VILLAGE OF GERMANTOWN
N112 W17001 MEQUON ROAD, GERMANTOWN, WI 53022

MEETING:	PLAN COMMISSION
DATE AND TIME:	MONDAY, APRIL 12, 2021 6:30 p.m.
LOCATION:	Germantown Village Hall Board Room, N112 W17001 Mequon Road

Village of Germantown Plan Commission
Meeting Agenda
April 12, 2021
#

SHEET NUMBER
C1.1

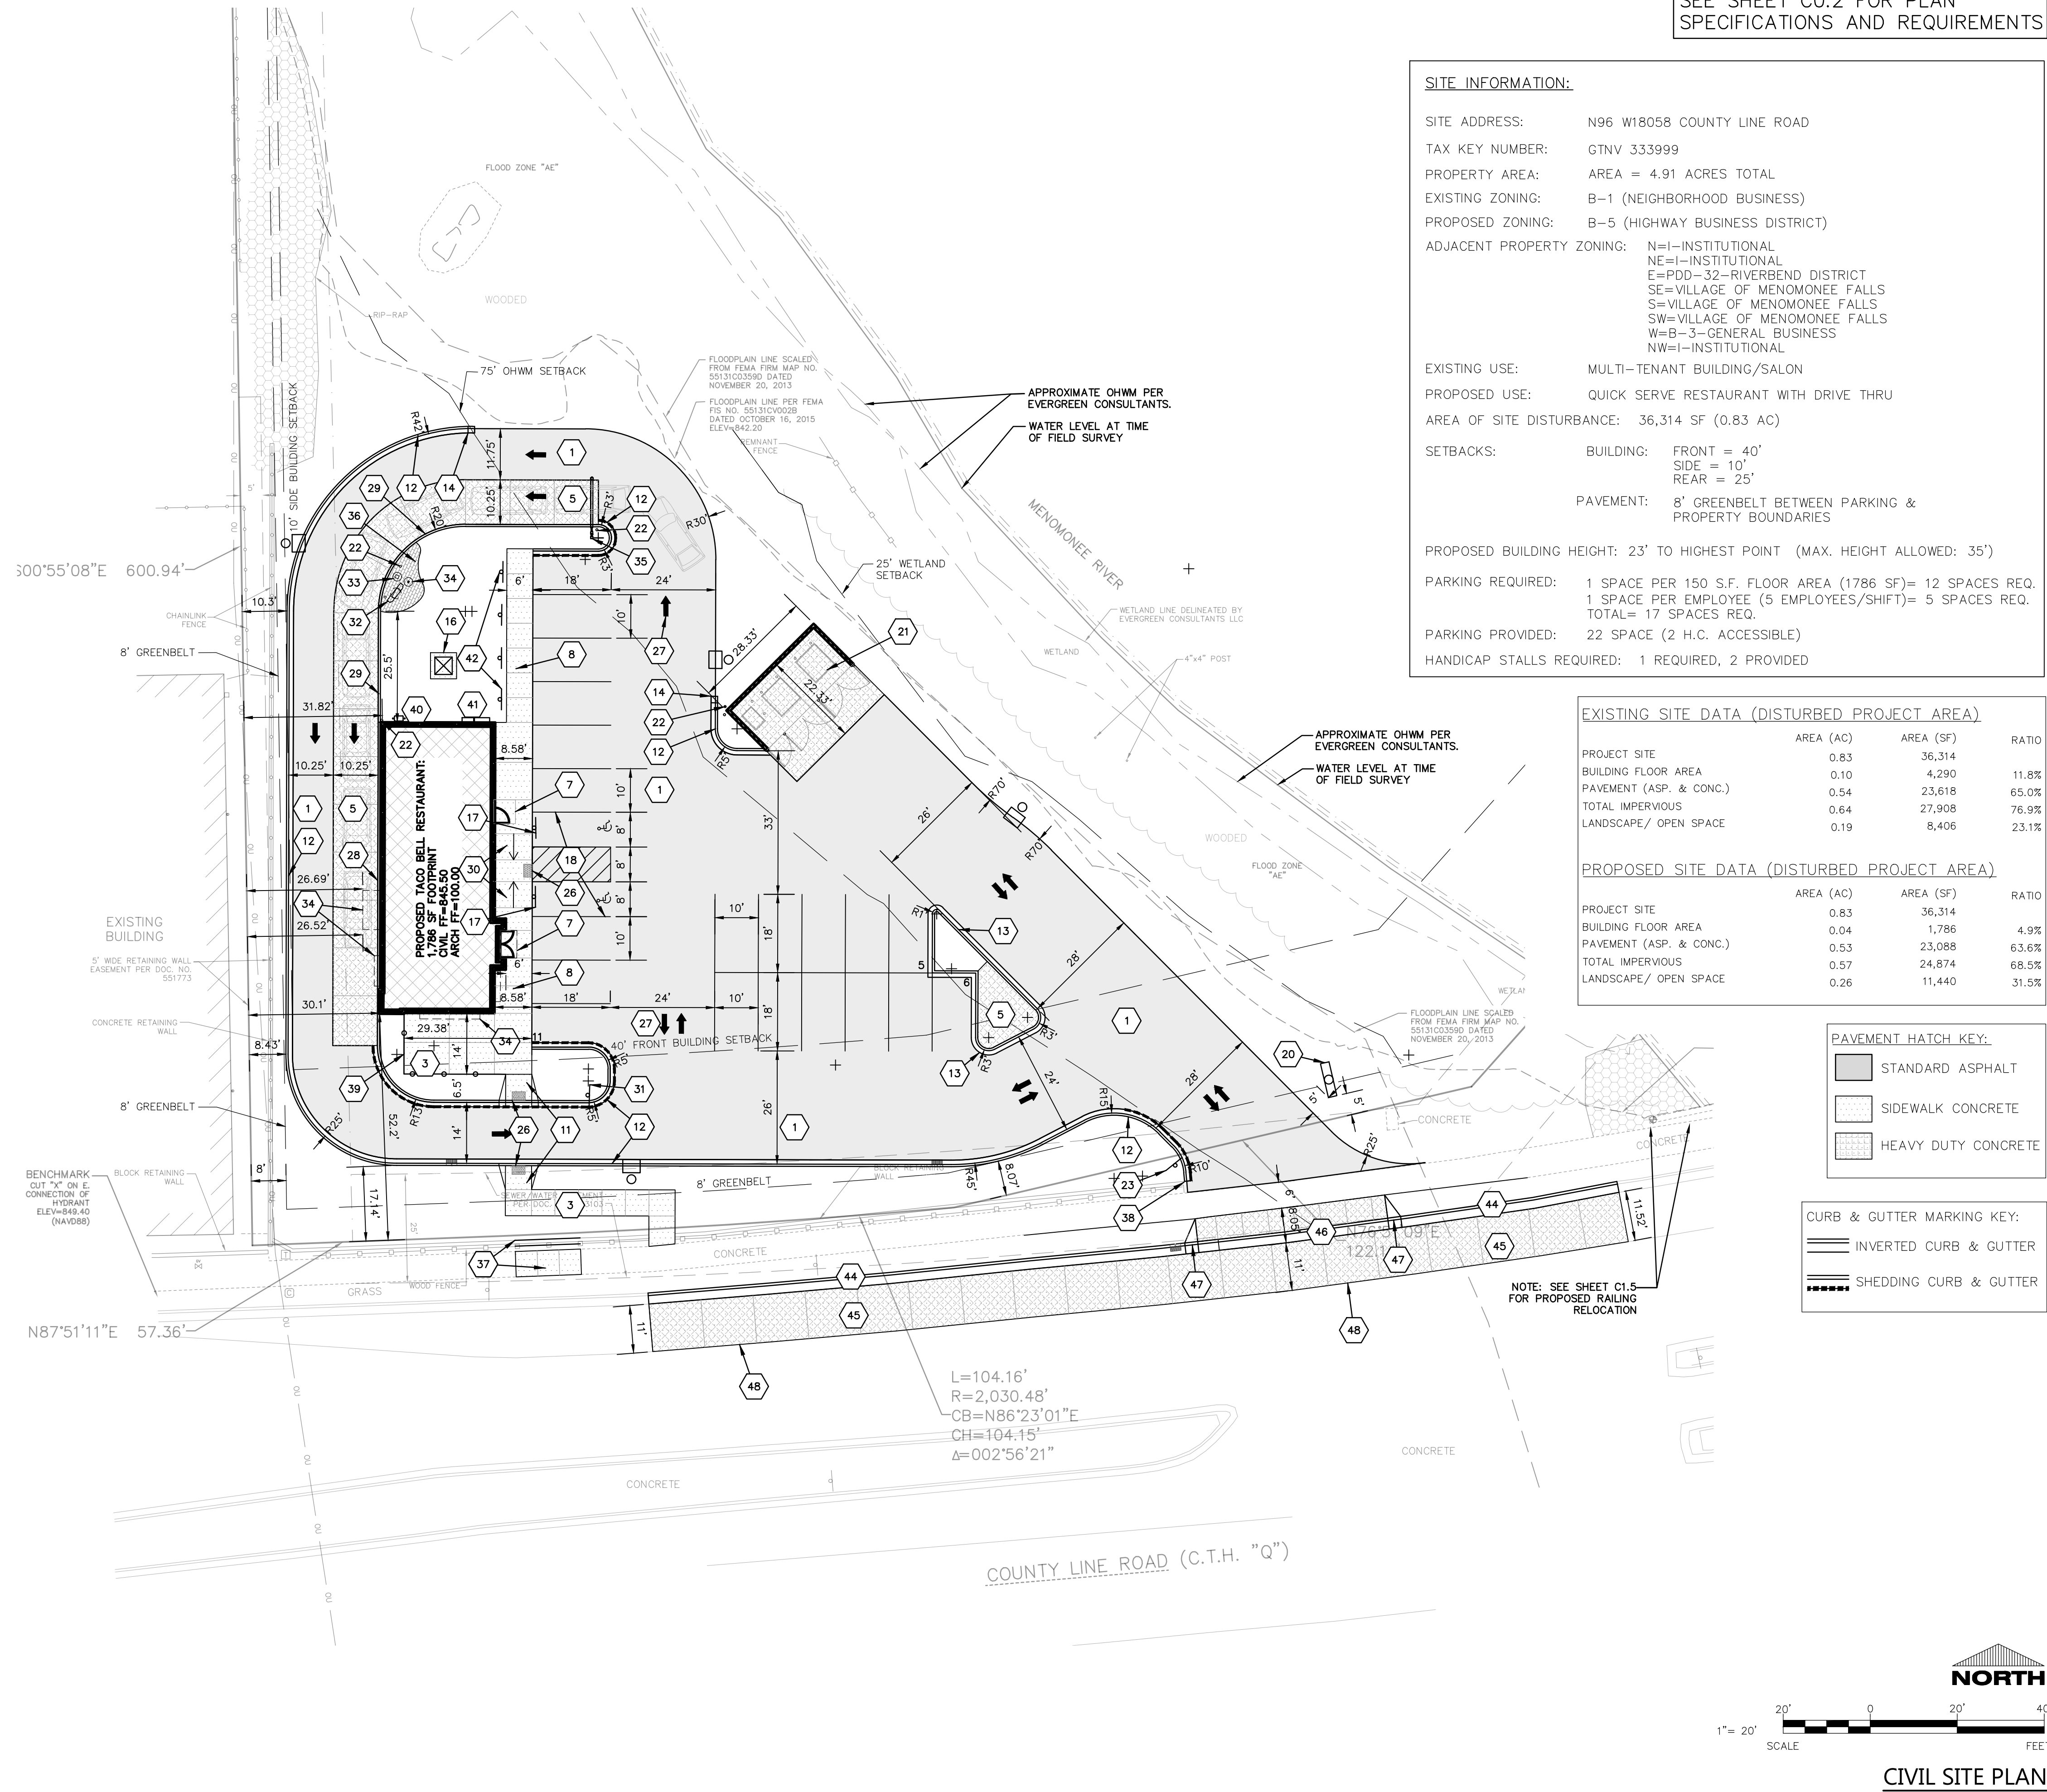
1. Note under Section 33-10-00(m) be revised to change the contact from “Kevin Korth” to “Jacob Tully”;
2. A Tracer Box be added and located on the north side of the building and shown on Sheet C1.3.

- b. A Tracer Box be added and located on the north side of the building and shown on Sheet C1.3.
 6. All technical issues and plan requirements listed in the January 6, 2021 memo from Public Works Director Larry Ratayczak shall be addressed in a revised civil engineering construction plan set signed & sealed by an engineer and approved by the Village Engineer/Public Works Department prior to issuance of a building permit and prior to commencing any new construction activities on the site (excluding demolition activities).

Excel Response: Plan specifications updated with above information. Note on C1.3 also updated as needed.

Excel Response: Note added to both the plan specifications and sheet C1.3

Excel Response: Village of Germantown standard sampling manhole detail added to sheet C1.3.
